Community Consultation Scheme

Proposed Revised Scheme

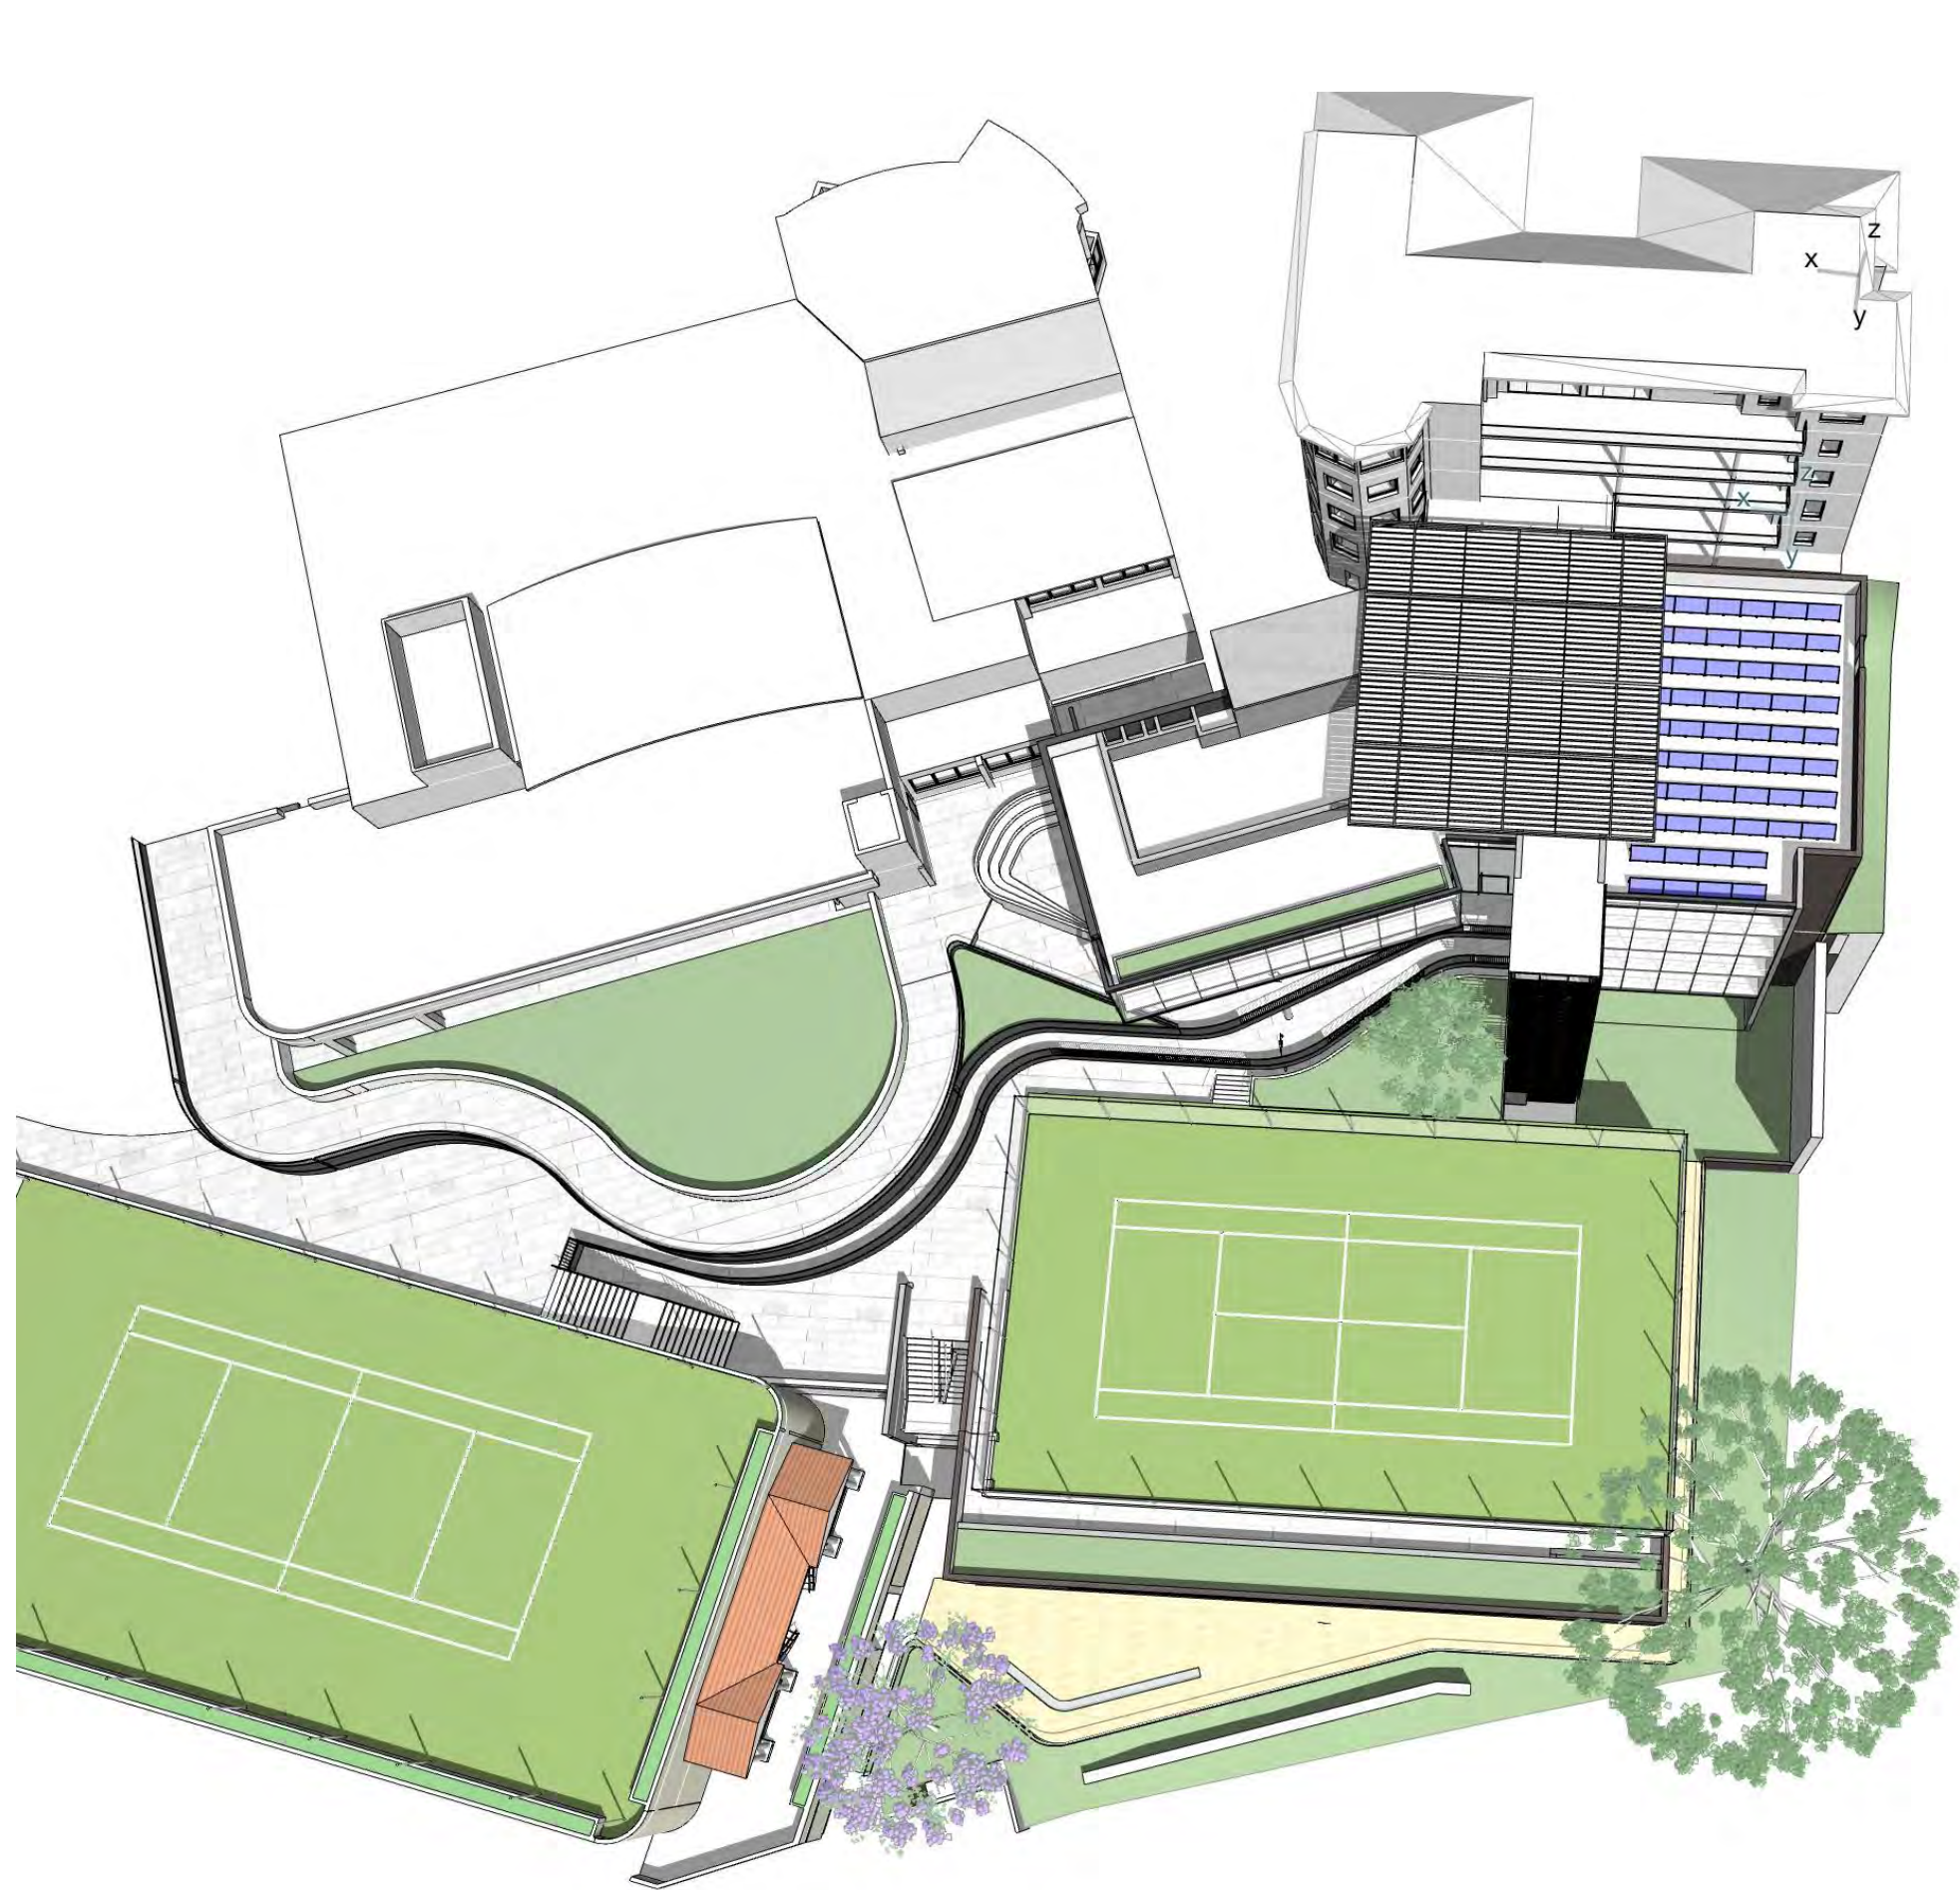
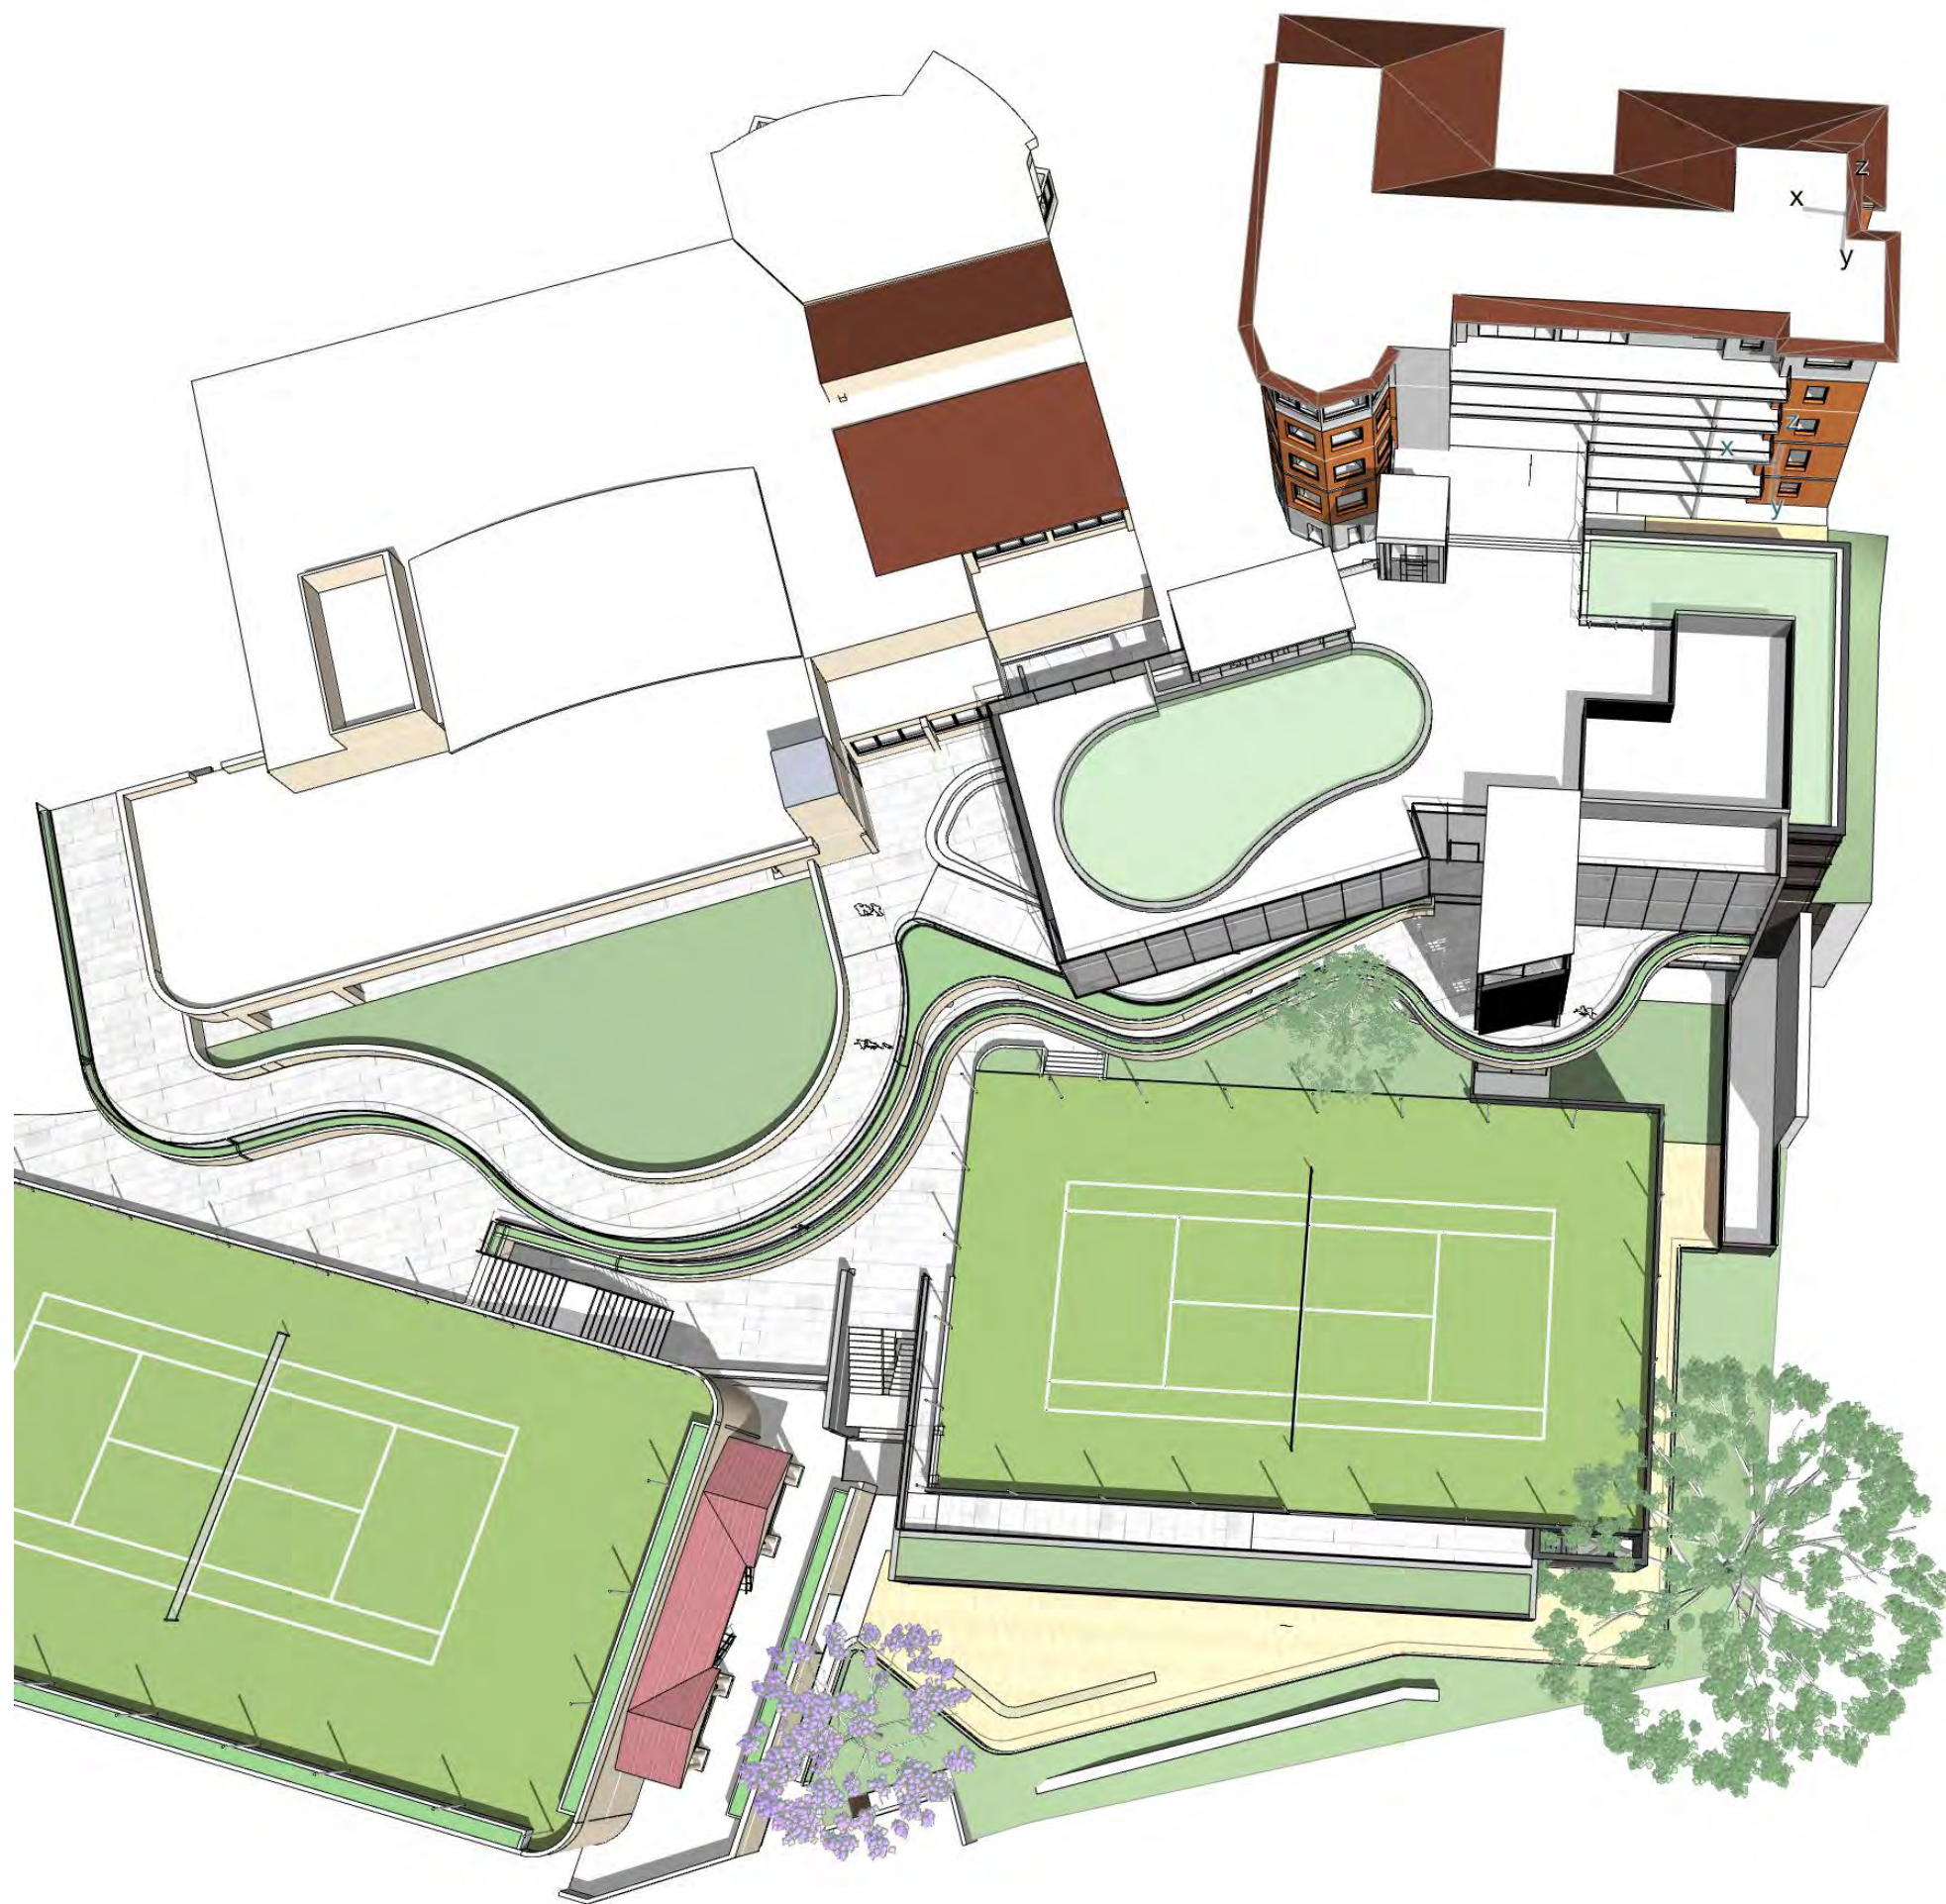
- 1 Parapet reduced in height
Integrated planter
creating a landscape
buffer to 111 Carabella St
- 2 Increased Roof Garden
- 3 Western boundary
facade articulation;
Introduced high level
windows and brick
detailing
- 4 Relocated Mechanical
Plant - Acoustically
treated
- 5 Building setback to
improve access to light
and air - 22 Elamang
- 6 Louvred roof removed
- 7 Glazed Lift
- 8 Reduced bulk and
scale of connector
form

Proposed Revised Scheme

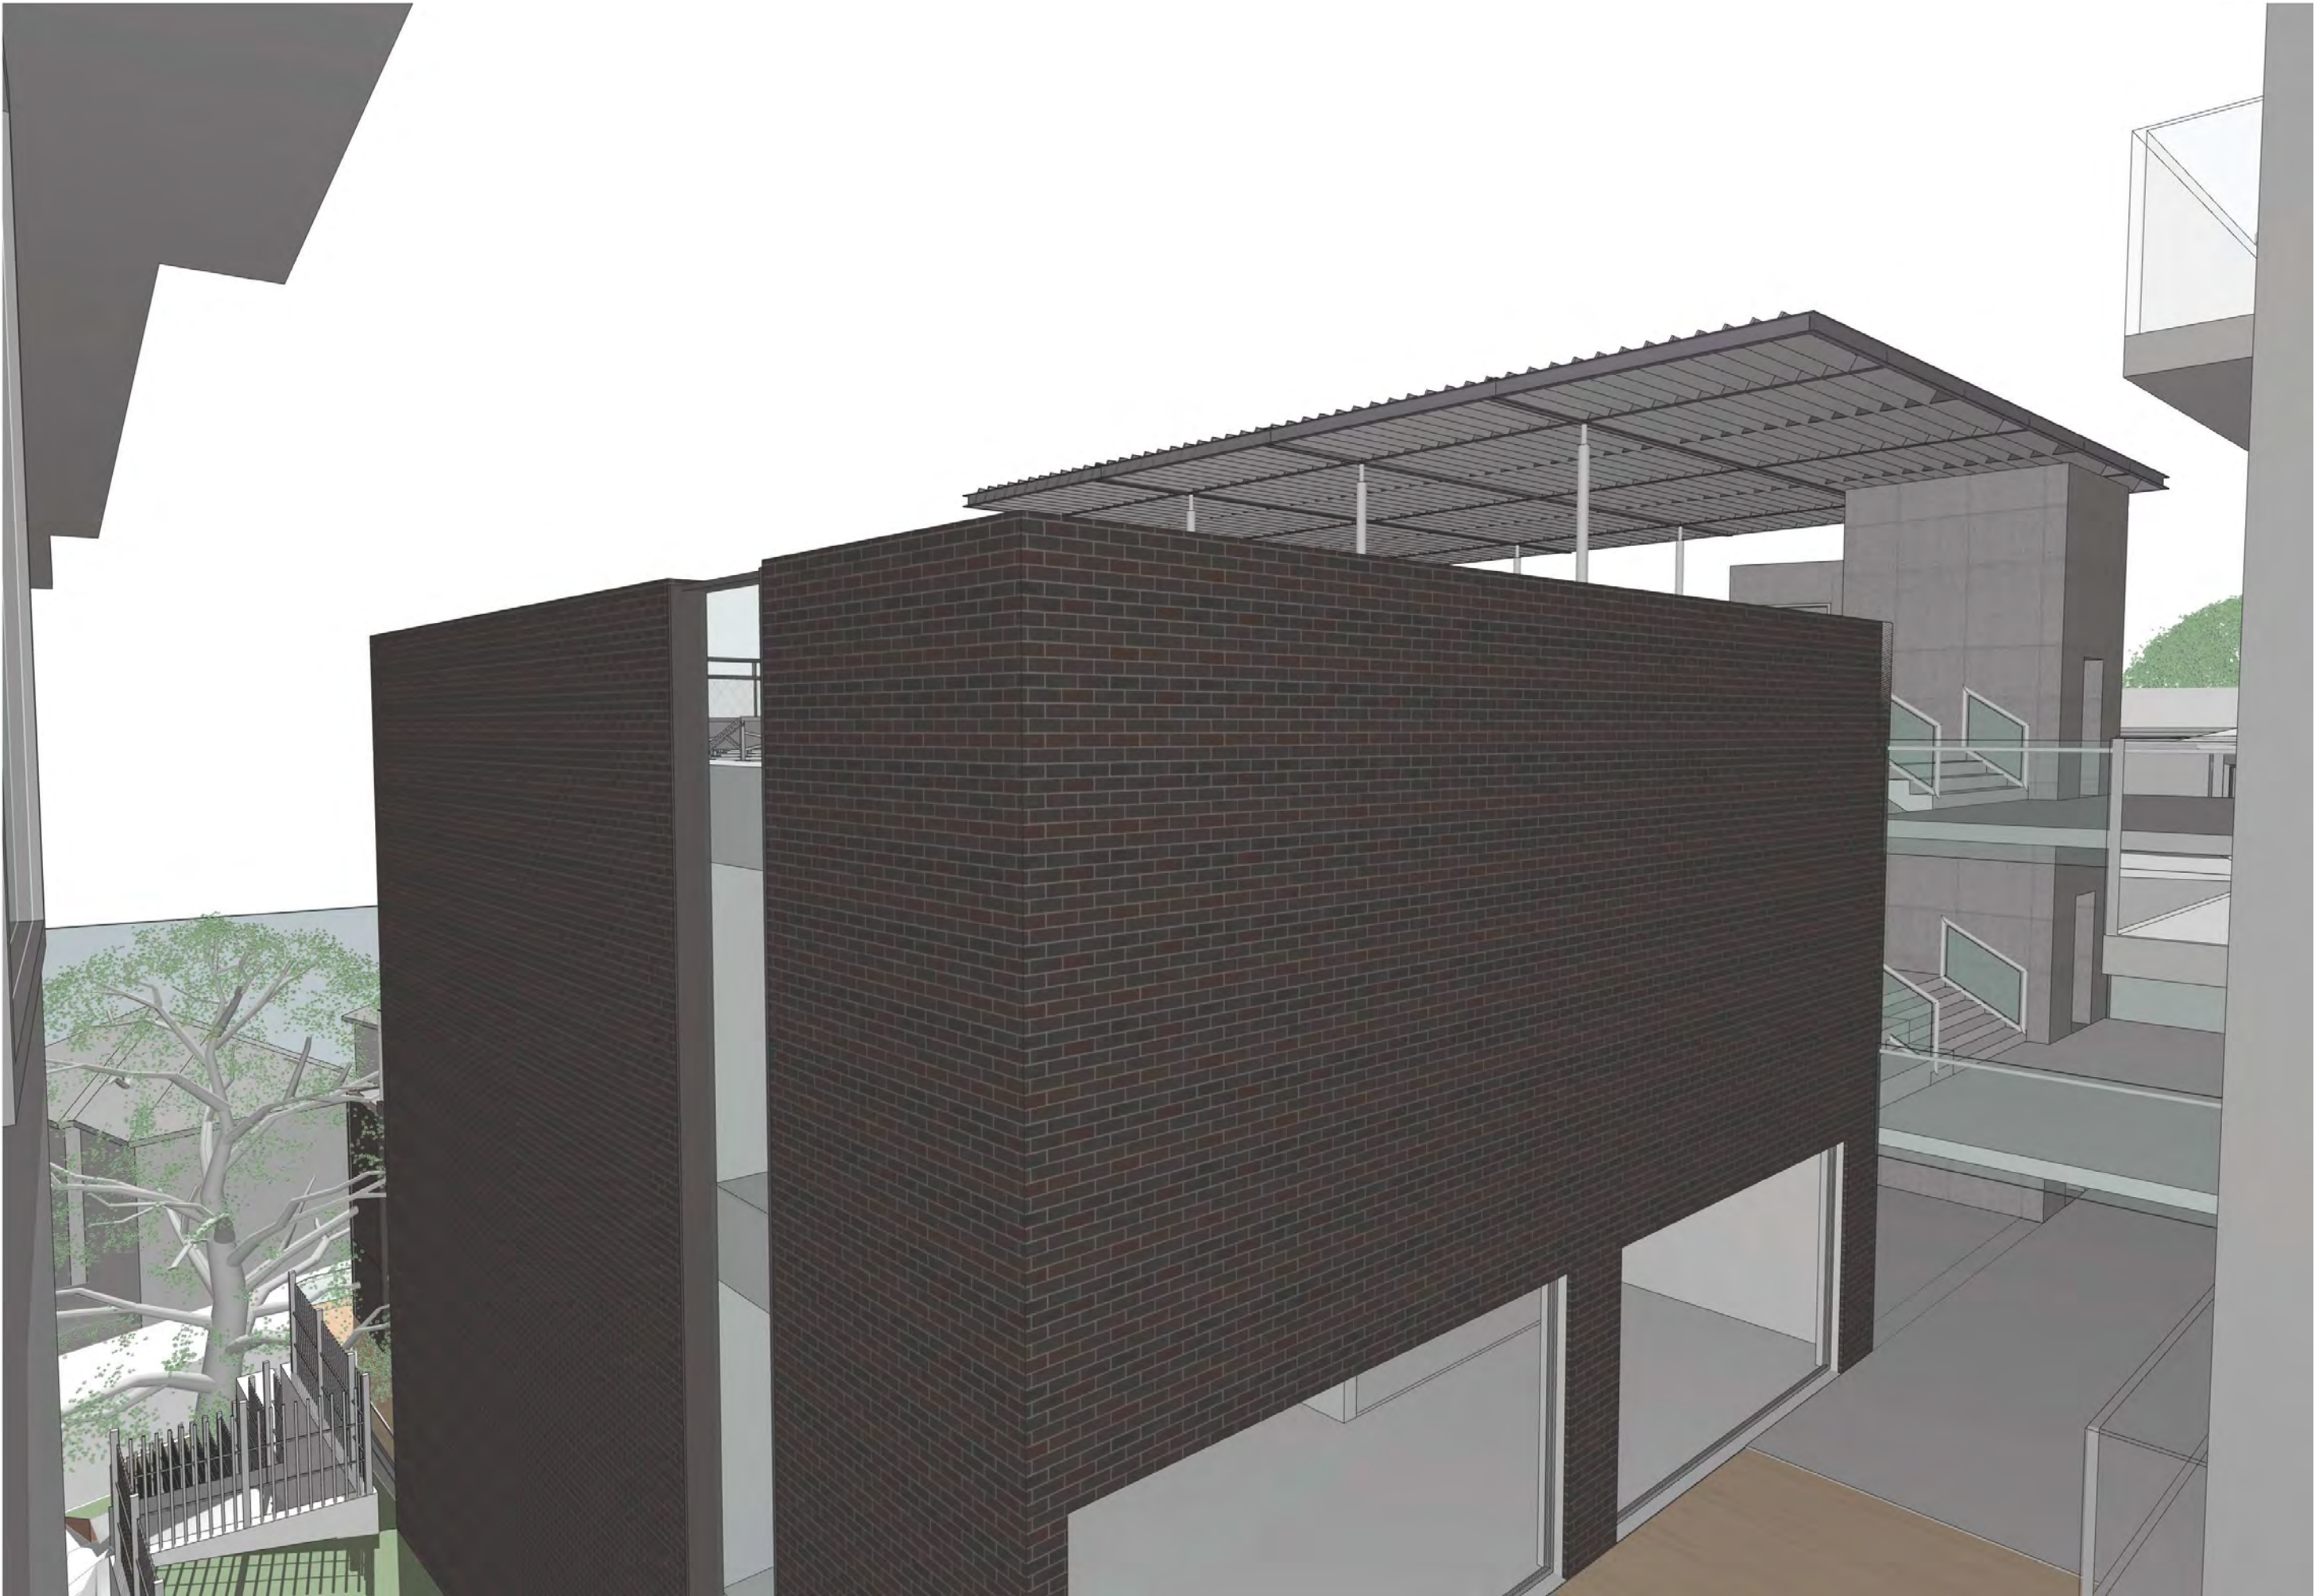
- 1 Parapet reduced in height
Integrated planter
creating a landscape
buffer to 111 Carabella St
- 2 Glazed lift
- 3 Introduced high level windows
and slot windows
- 4 Privacy screen
- 5 Brick detailing
